## PLANNING TECHNICAL REVIEW COMMITTEE –AGENDA

## PLAN SNAPSHOT REPORT WAIV-2023-0006 FOR CITY OF DOVER, N.H.

**RE: Second Street Courthouse – Site Plan Amendment  
10 Second Street  
Dover Planning File: P21-30**

**TO:** Donna Benton, Planner, City of Dover      **DATE:** 6/8/2023  
**FROM:** Neil J. Rapoza, PE  
CIVIL CONSULTANTS  
**SUBJECT:** Plan Revision Memo  
**PROJECT:** 20-279.00 One First Street, LLC (Dover project #P21-30)

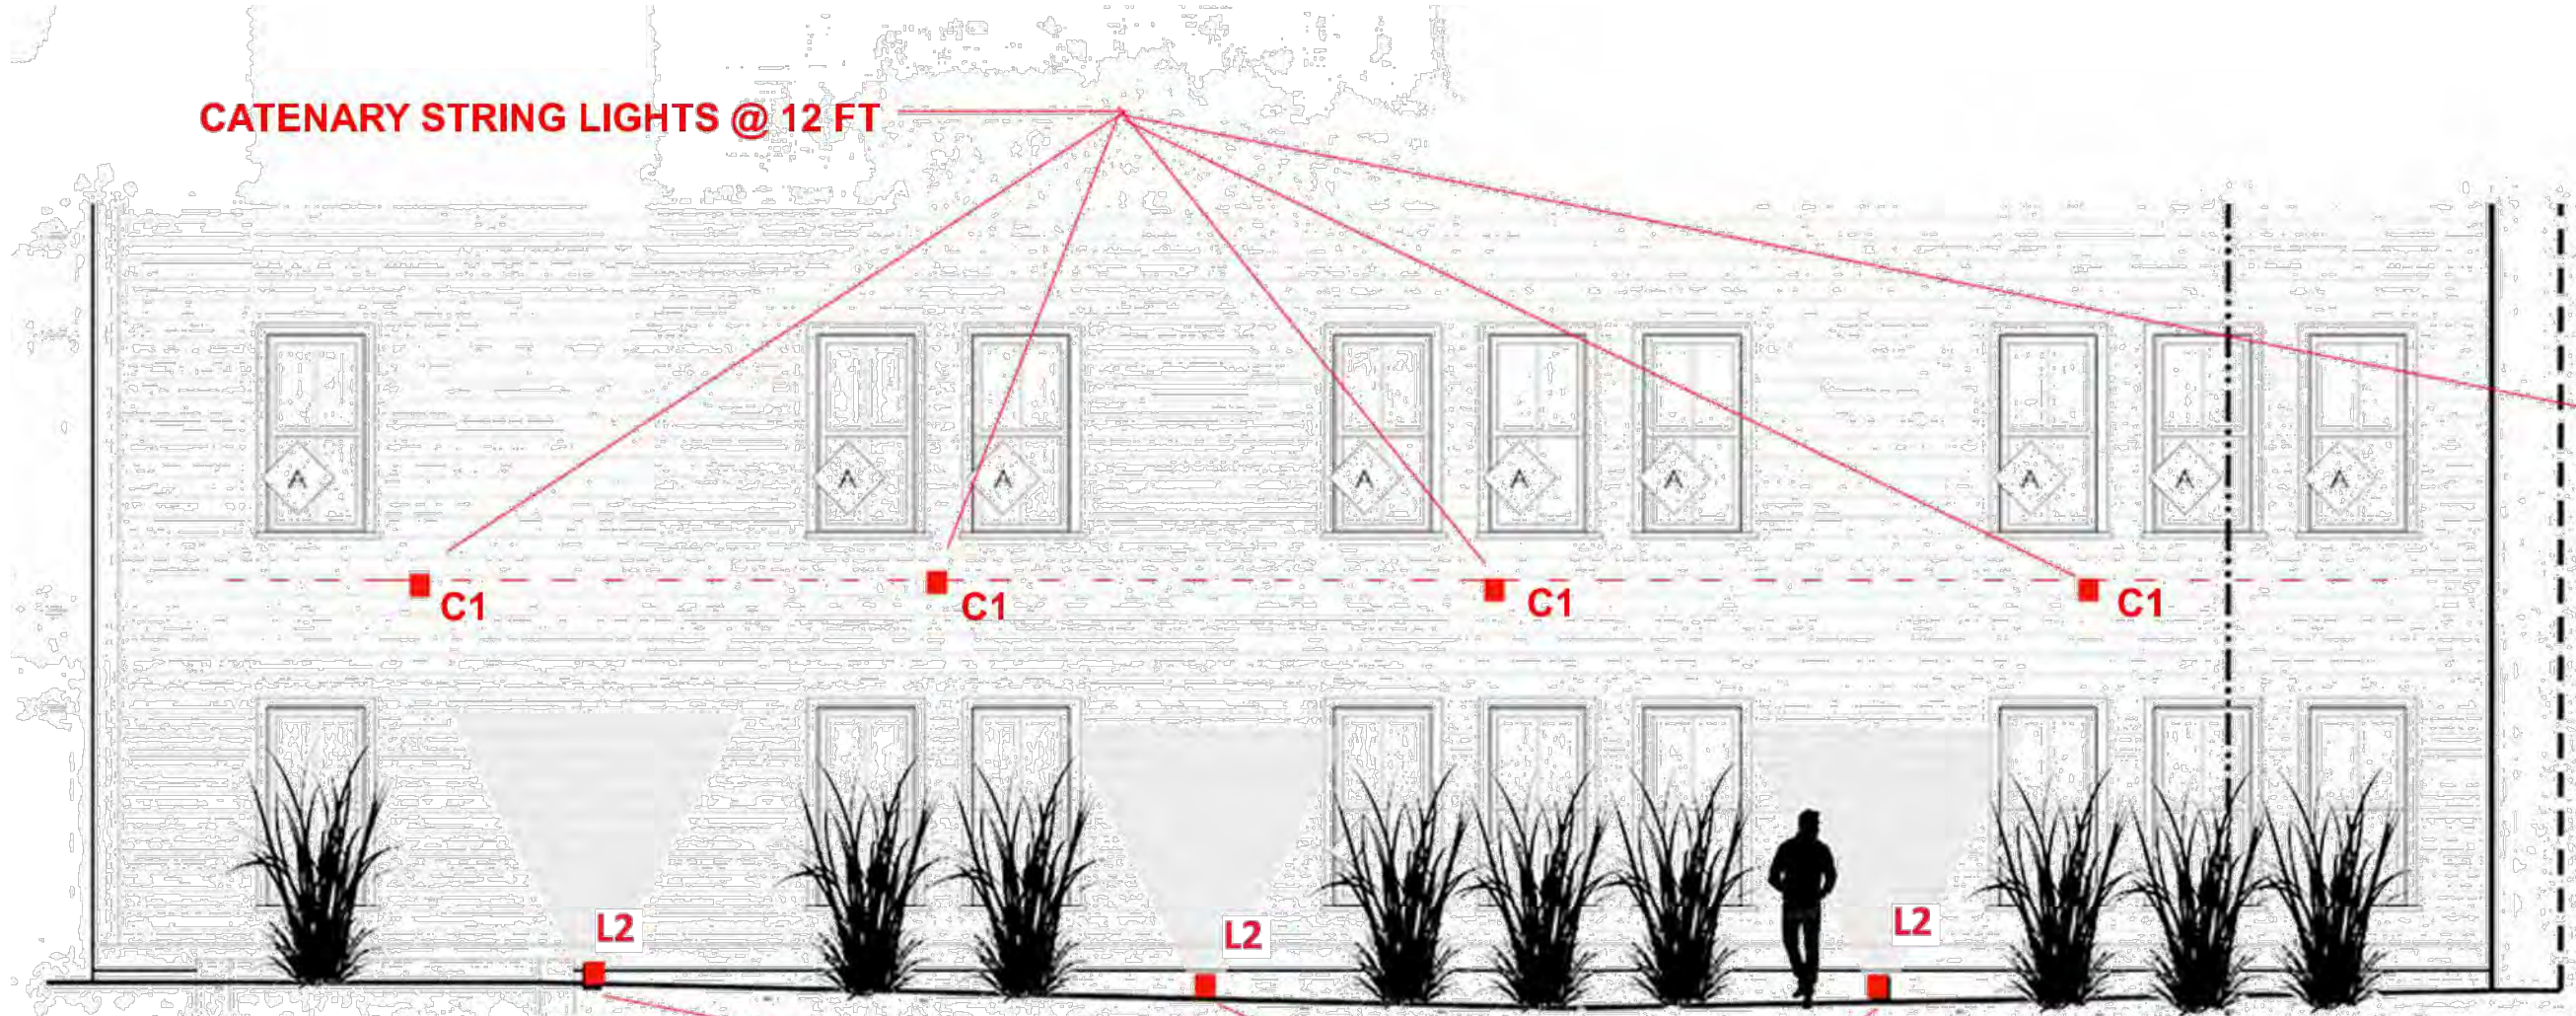
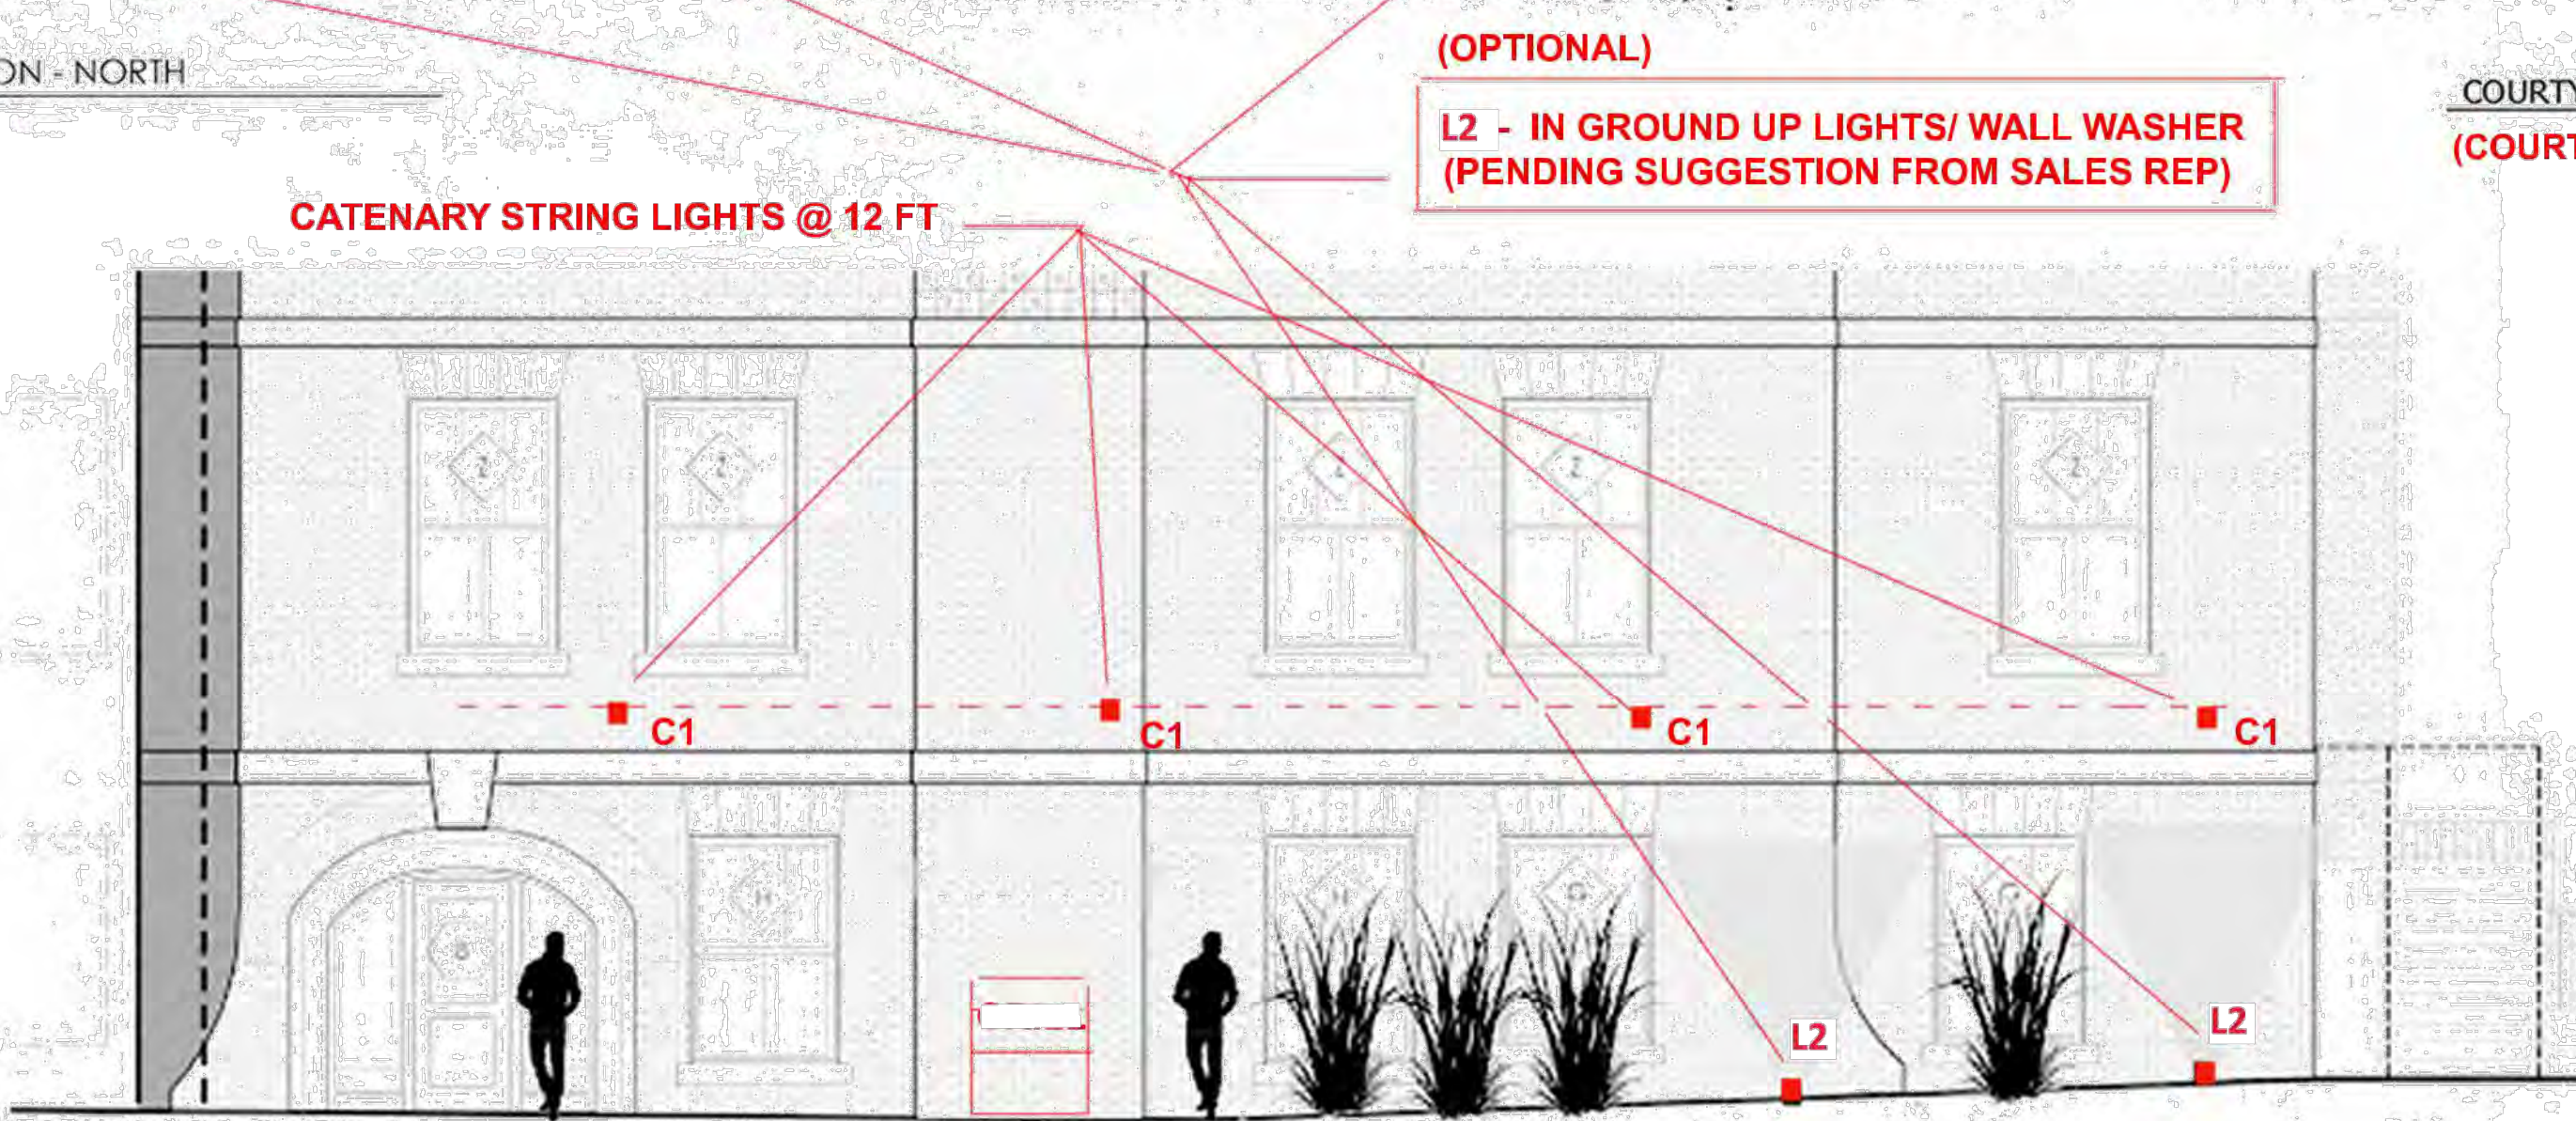
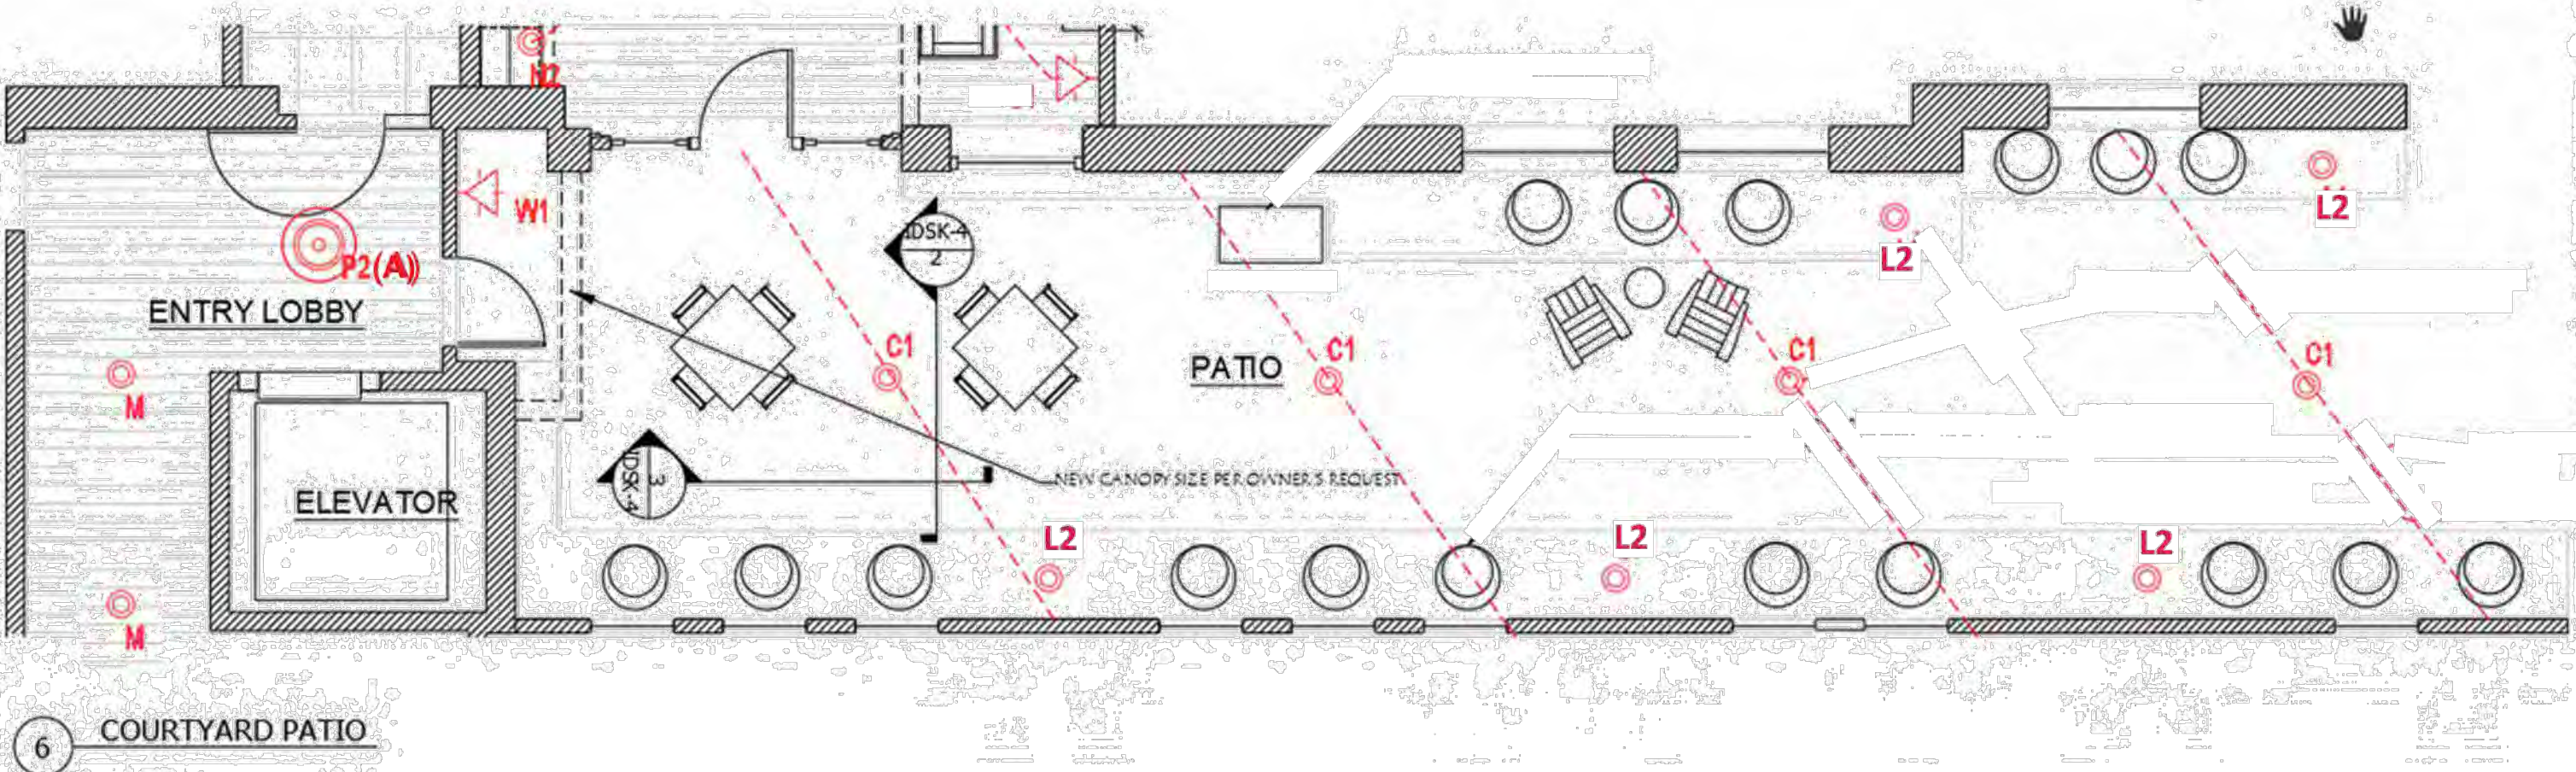
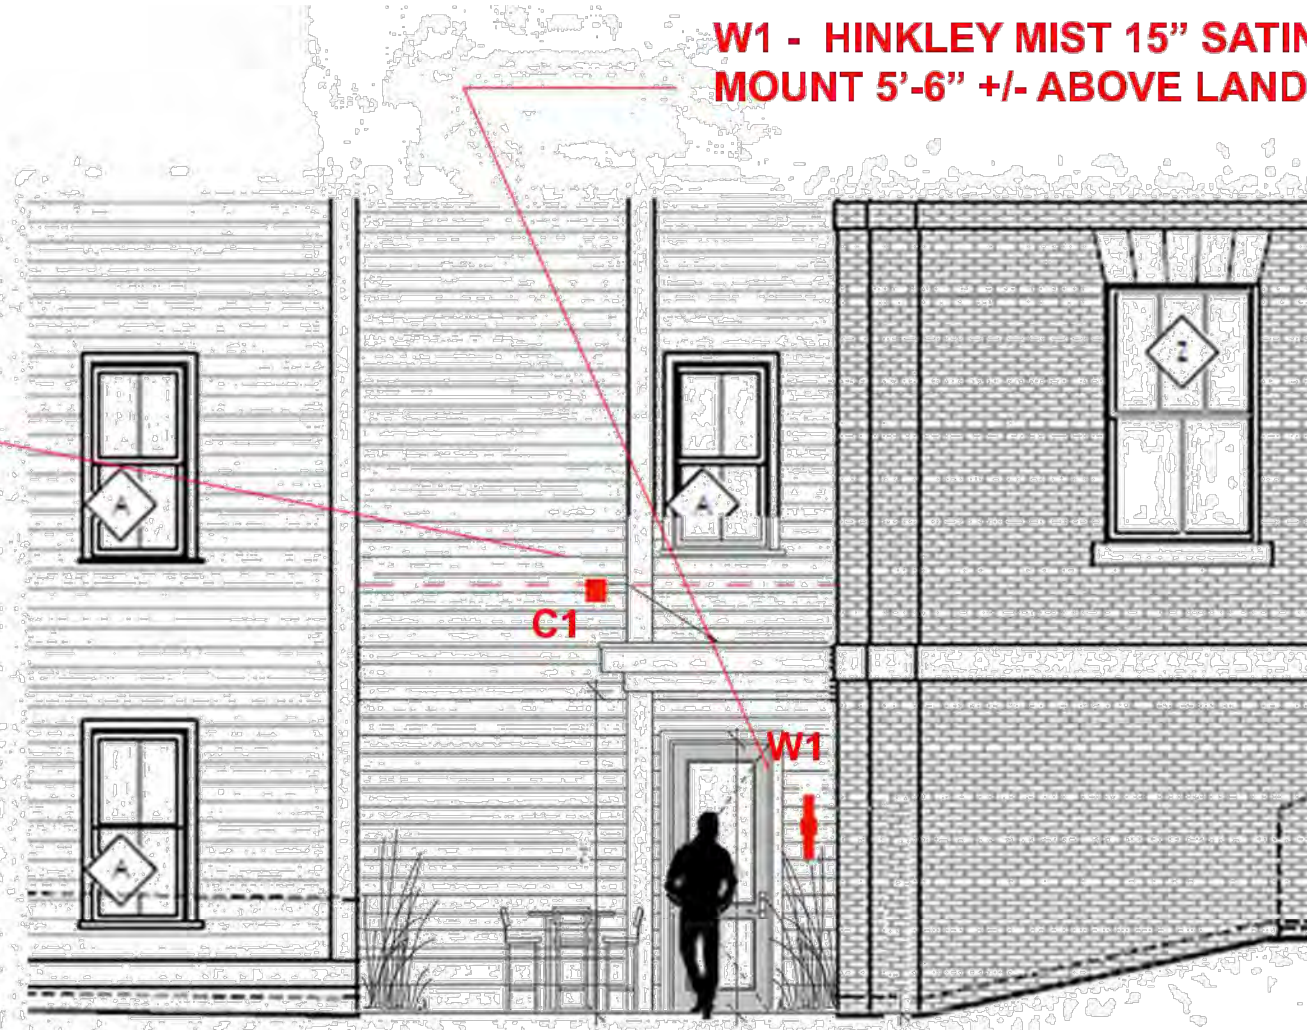
### Sheet LP7

- a. This sheet added to indicate lighting elevations and fixture depictions, Interior Courtyard and North entrance of building.
